NORTH LINCOLNSHIRE GREEN ENERGY PARK

9.17 Comments on Written
Representations

PINS reference: EN010116

January 2023

Figure 1: Treatment capacity in England with High/Medium CCS potential

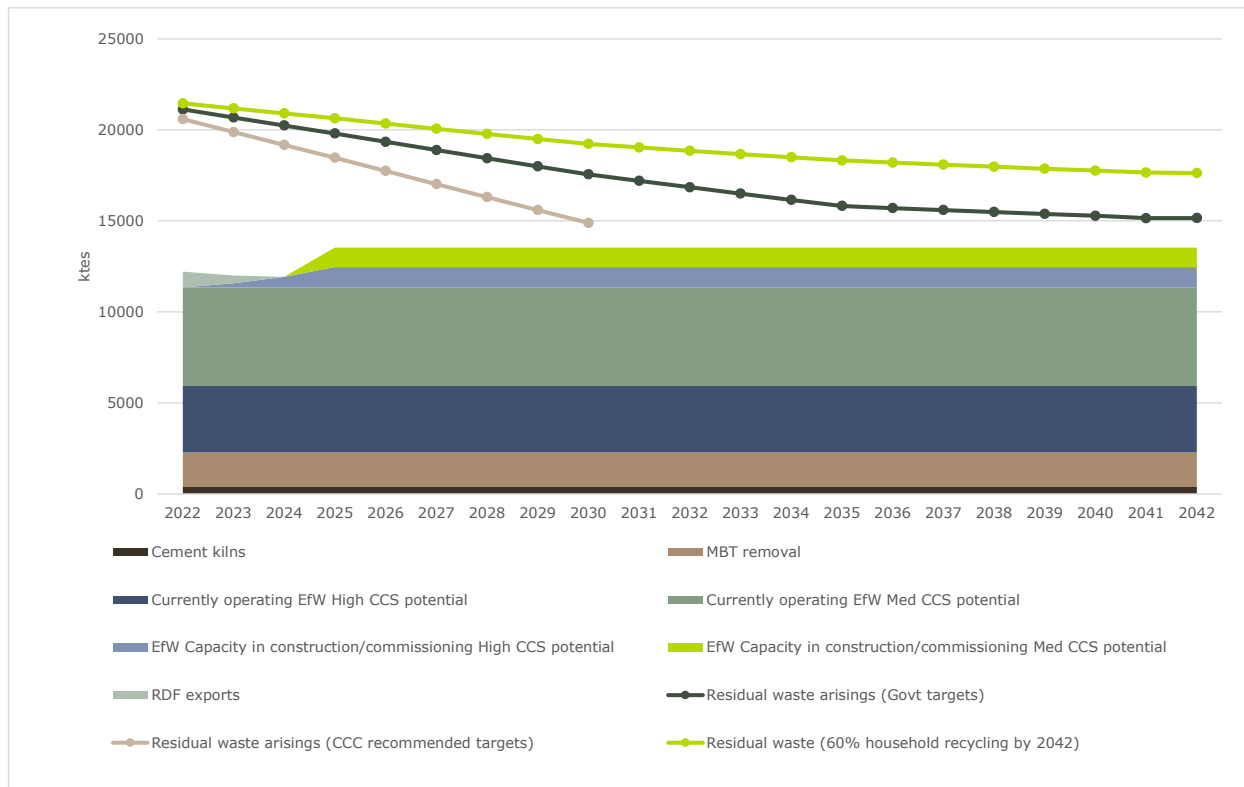
We acknowledge UKWIN's comment that the Rivenhall Airfield project has now entered the construction phase and this is accounted for in Figure 1 above. UKWIN states that the Applicant has under-stated the capacity of existing facilities by 514 kte per annum. We have investigated this and

Figure 1 shows our assessment of existing and under-construction capacity which has a high or medium CCS potential⁴. This suggests that there is insufficient capacity to treat residual waste arising after recycling and waste reduction targets are met, and assuming all of the plants which have a high or medium CCS potential are successful in achieving CCS.

made adjustments where we accept UKWIN's view – this amounts to an increase of 378 kte (also reflected in Figure 1). We have also added in an assumption that 375 kte per annum of residual waste is used in cement kilns⁶. These adjustments do not affect the main conclusion of the RDF Supply Assessment that there is insufficient capacity to treat residual waste arising after recycling and waste reduction targets are met, based on our view of plants which have a high or medium CCS potential.
